Docket Item # 1 & 2
BAR CASE #2015-0164 & 0165

BAR Meeting
January 27, 2016

ISSUE: Permit to Demolish/Capsulate and Certificate of Appropriateness for an Addition and Alterations

LOCATION: 211 North West Street

REVISED SKETCH

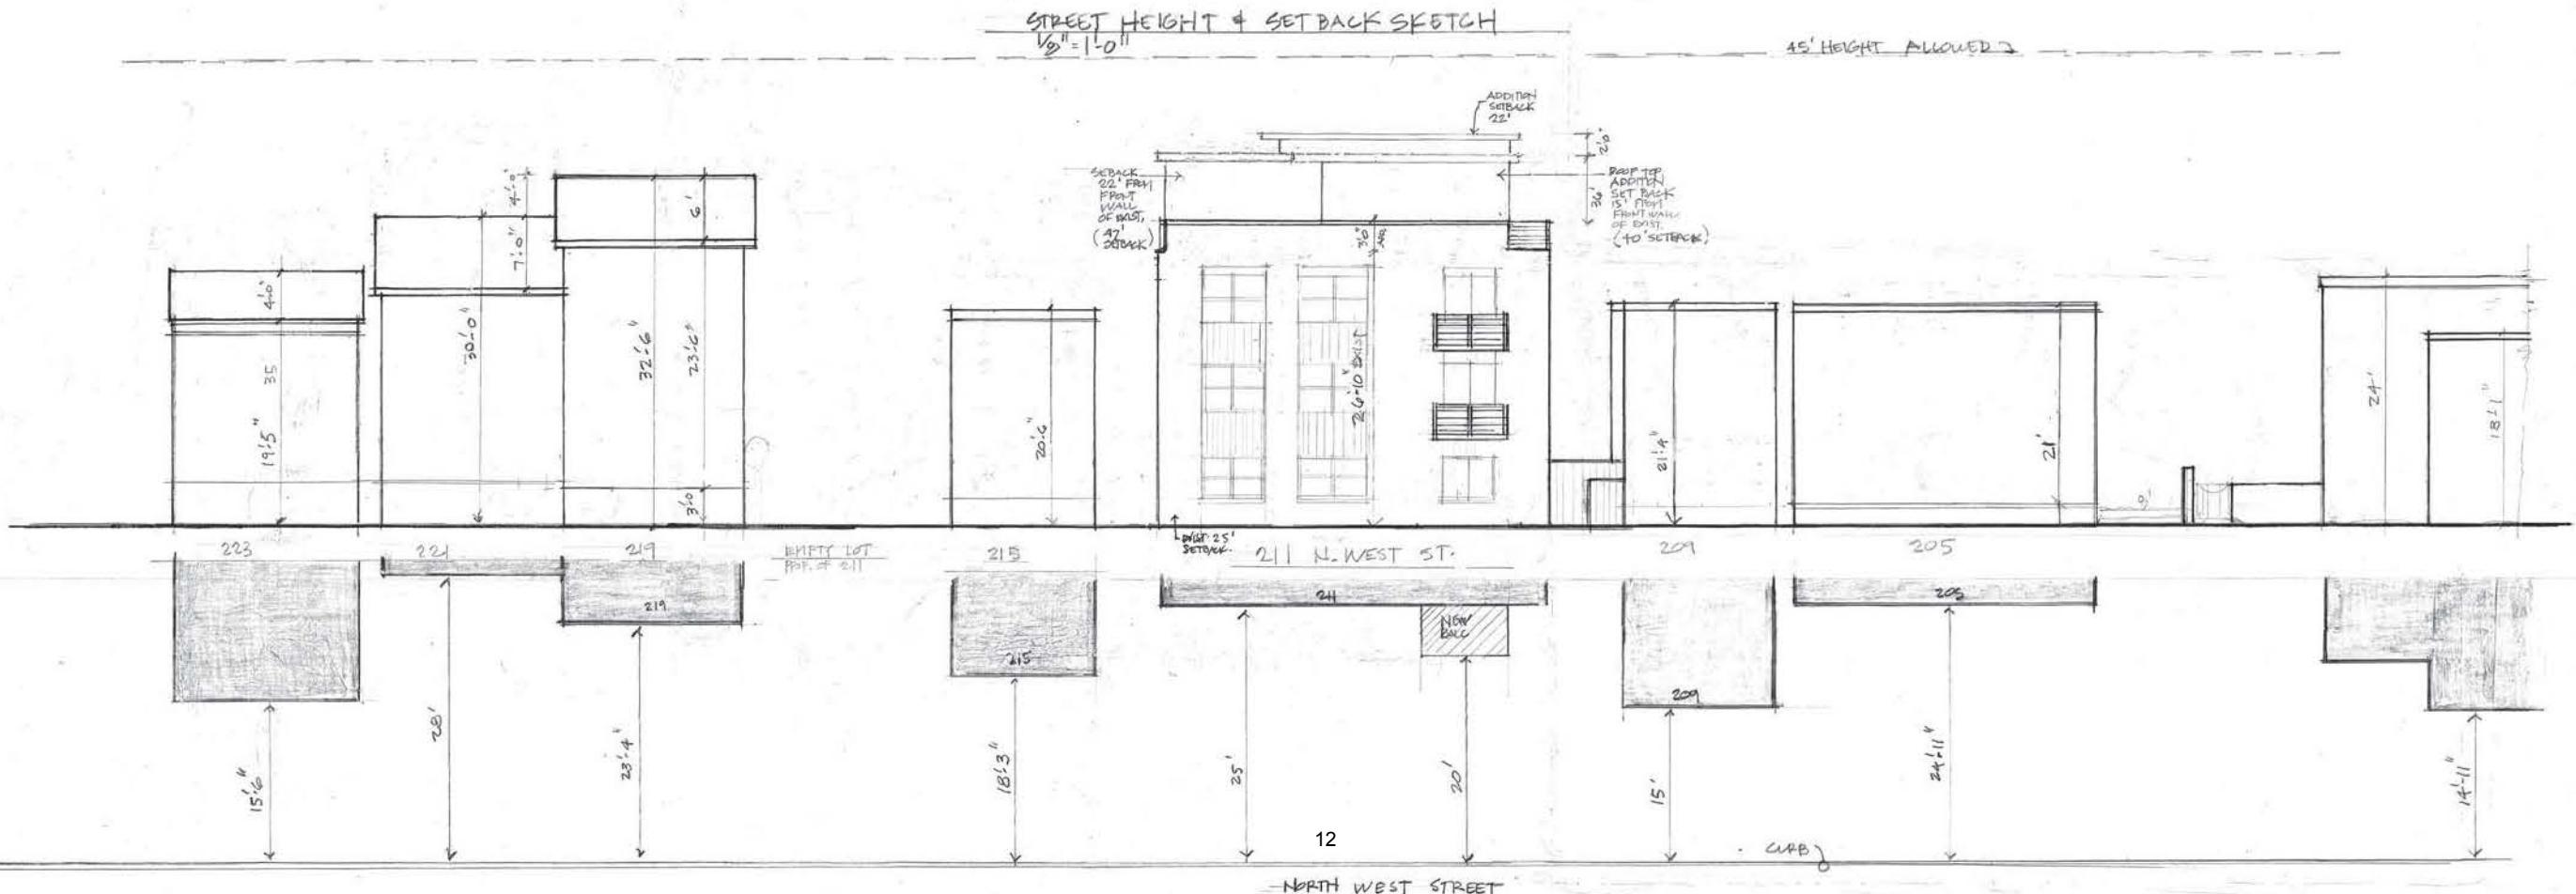
SETBACK * REvised DESIGN.
BACK * SEE DESIGN FOR GREATER T
AVG SET BACK

1 11 * REVISED DESIGN

1. UPPER ROOF 1'-0" OVERHANG - @ NORTH & SOUTH EAVES.
2. FRONT BALCONY MEETS 5'-0" SIDE YARD SETBACK
3. SOUTH WALL ADDITION MEETS 5'-0" SETBACK
4. NORTH WALL ADDITION MEETS 5'-0" SETBACK
5. FRONT NUMBERS - MOUNTED TO WEST WALL PROJECTION - GREEN WALL
6. FRONT BALCONY PROJECTS 1'-0" W/ NO VERTICAL POSTS

F. Open Space Calculations

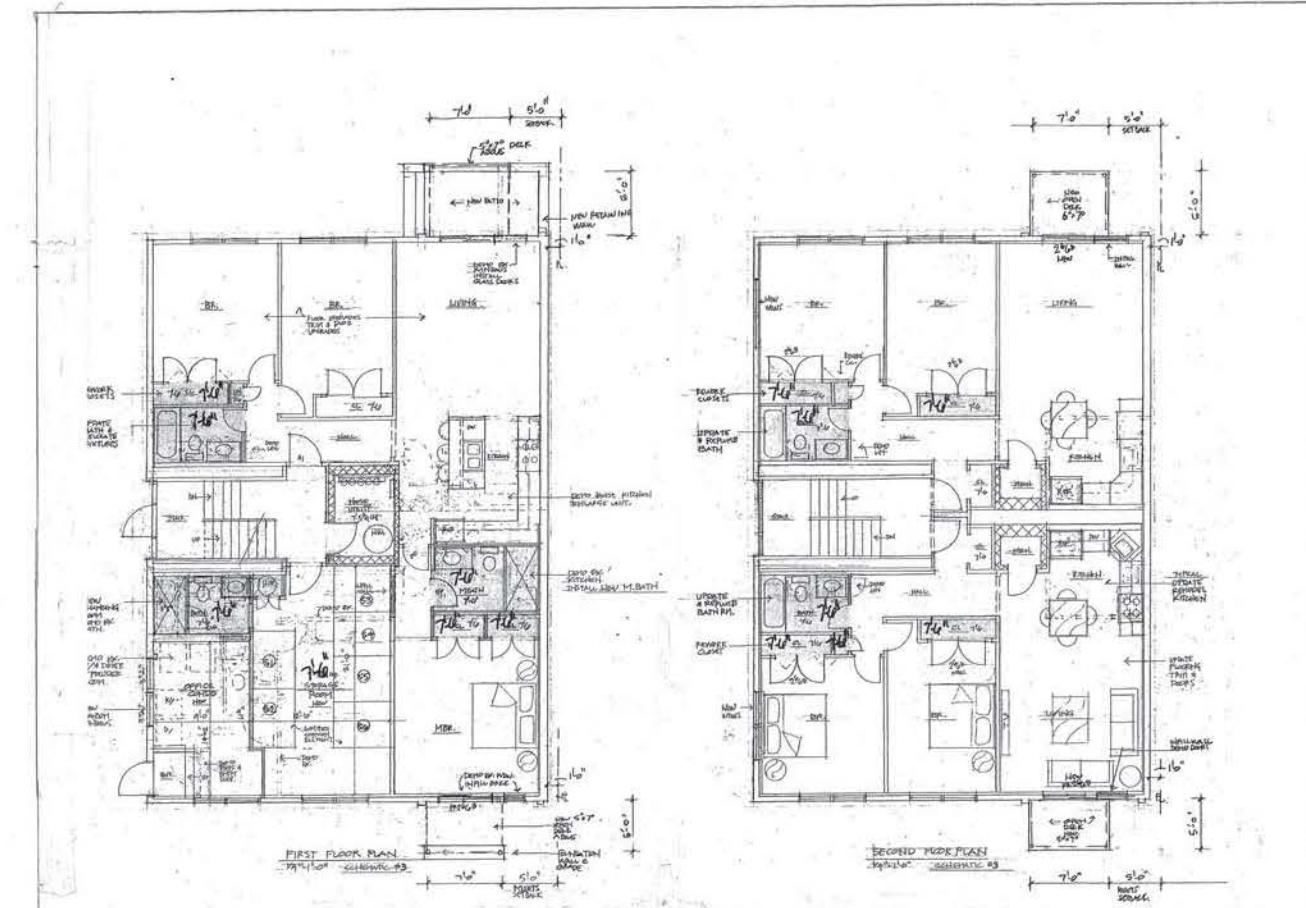
- Applicant will need to submit an open space plan. Only open space areas at least 8' by 8' in dimension can be included.
- Response: Open space plan still required. Proposed open space on the form and under zoning data is different. Calculations must be consistent and supported by open space plan.

Existing Open Space: 5813 ft

Required Open Space: 4800 ft

Proposed Open Space: 4890 ft
